City of Charlottesville, Virginia
Ragged Mountain Project

**Subject: REVISED Opinion of Probable Construction
Costs for Modifying the Lower Ragged
Mountain Dam
Ragged Mountain Project**

TECHNICAL COMMENTS FROM ITRT

ALTERNATIVE 1 PLAN AND SECTIONS

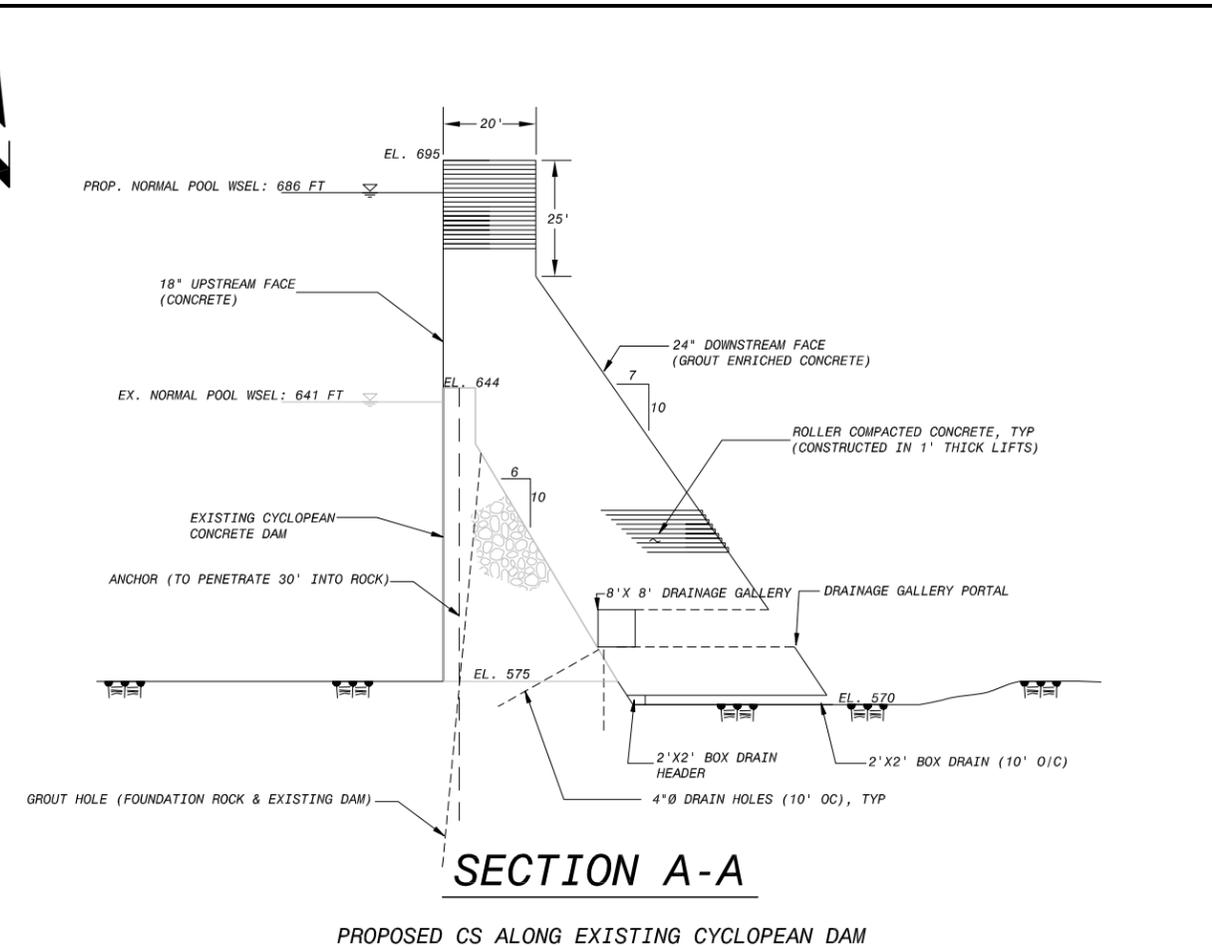
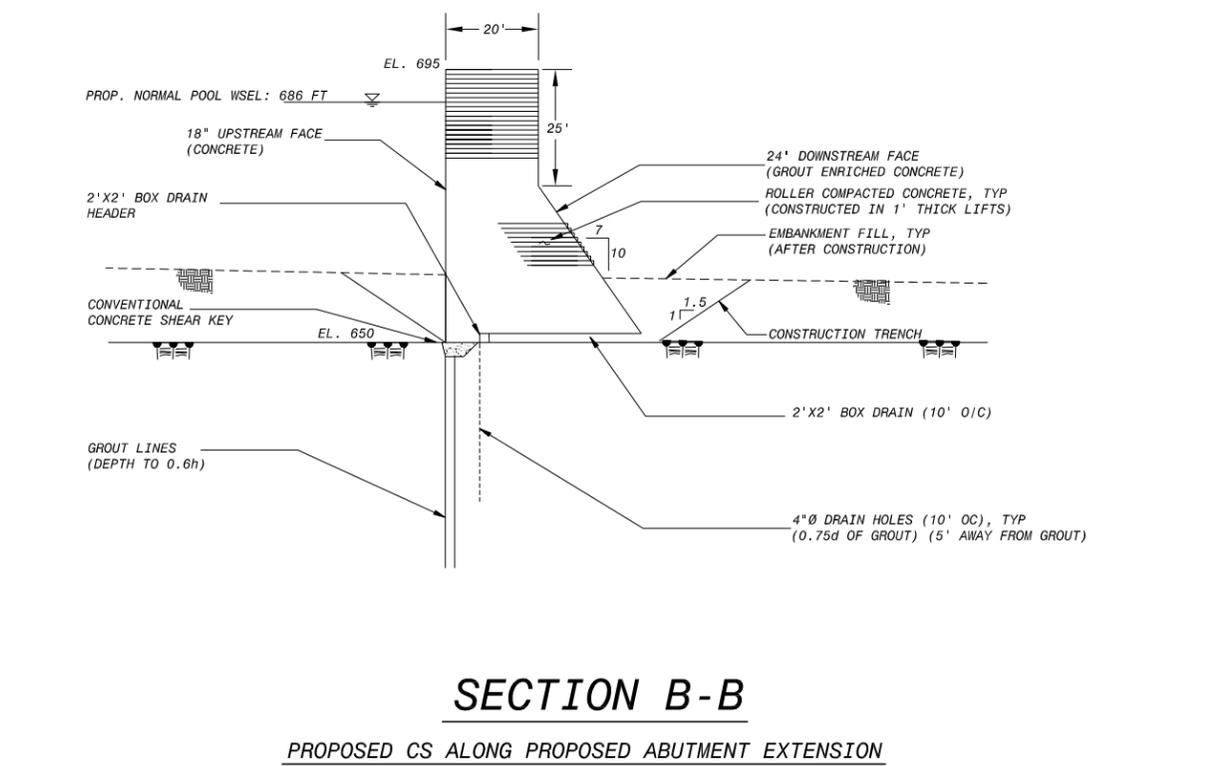
Dam Section and Stability – *A stability analysis should be performed to assess the performance of the proposed dam raise. The crest width of the RCC section should be at least 20 ft wide. The quantity of RCC should be checked.*

Black & Veatch completed simple stability analyses of the proposed raised LRMD to verify the safety of the assumed geometry. The RCC crest width was increased to 20 ft for constructability. The spillway section was reduced from 100 ft wide to 50 ft wide based on hydrologic data provided in Schnabel Engineering's report entitled Preliminary Design Report, dated May 14, 2010.

A maximum cross section with a 20 ft wide crest, a 25 ft high chimney section, and a 90 ft wide base at elevation 570 ft, was developed. The base width is equivalent to a 0.7H:1V downstream slope. It was assumed that the entire base is horizontal at elevation 570 ft; although, actual base geometry will be considerably more undulating. Attachment B illustrates the assumed maximum section.

Based on the analyzed cross section, the total quantity of RCC required is estimated at approximately 54,900 cubic yards. If the project proceeds into design, it may be possible to optimize the cross section to reduce the quantity of RCC while satisfying required safety factors.

RAGGED MOUNTAIN DAM STUDY
ALTERNATIVE 1 PROFILE

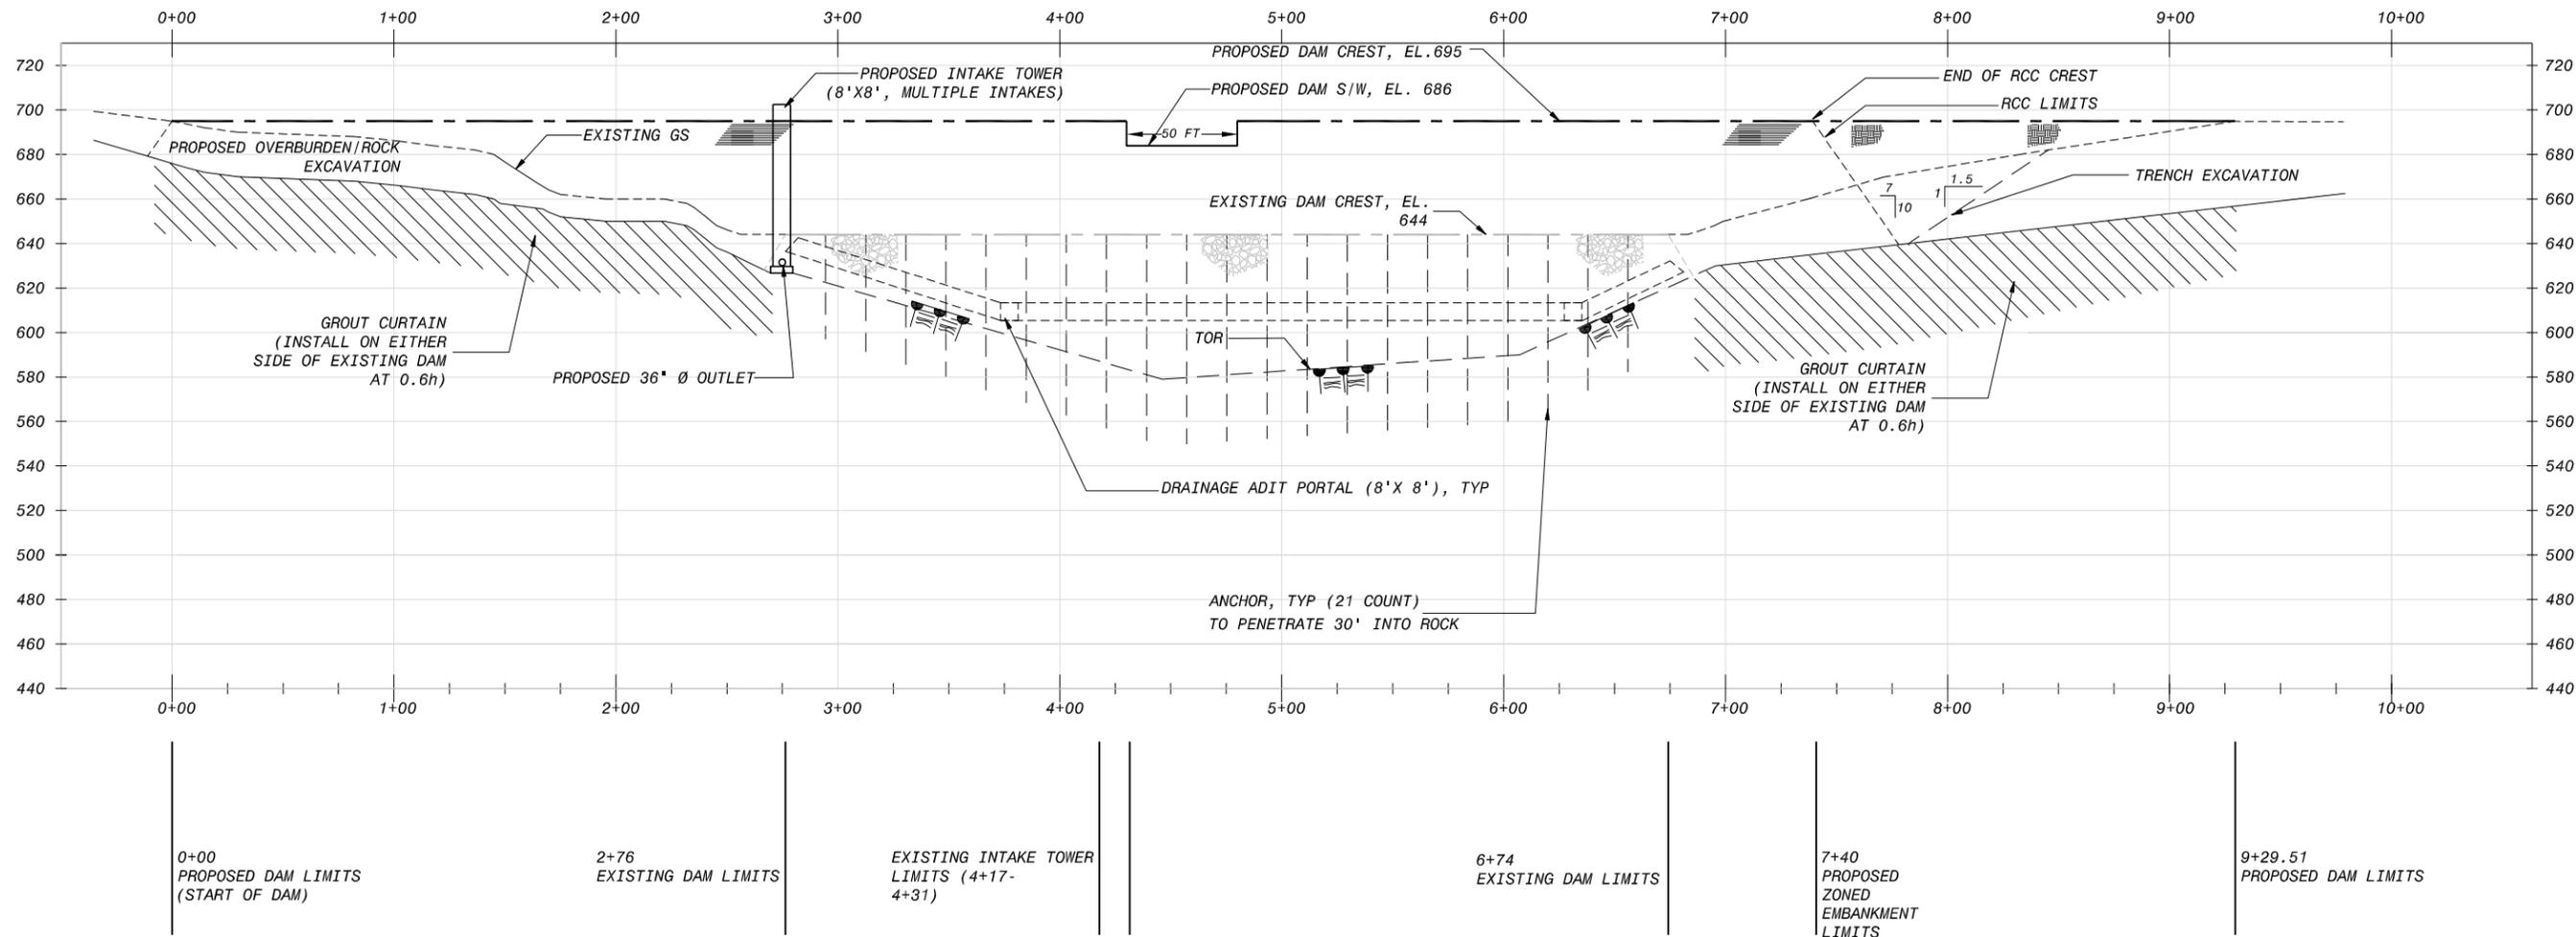
Outlet Works – *the existing outlet works is not reliable and does not have the required capacity to meet future use demands.*

Regarding the questions concerning the condition of the existing intake tower and gates, we suggest satisfying these needs through construction of a new intake tower located on the left abutment adjacent to the existing dam as shown on Attachment C. The tower would be attached to the upstream face of the RCC and include three 36-inch diameter intake levels (controlled with sluice gates) with the lowest at about elevation 630 ft. An intake at elevation 630 ft will allow access to approximately 89 percent of the reservoir volume with the remaining 11 percent providing dead storage. A 36-inch diameter pipe would extend through the RCC dam, along the left abutment and connect to existing piping.
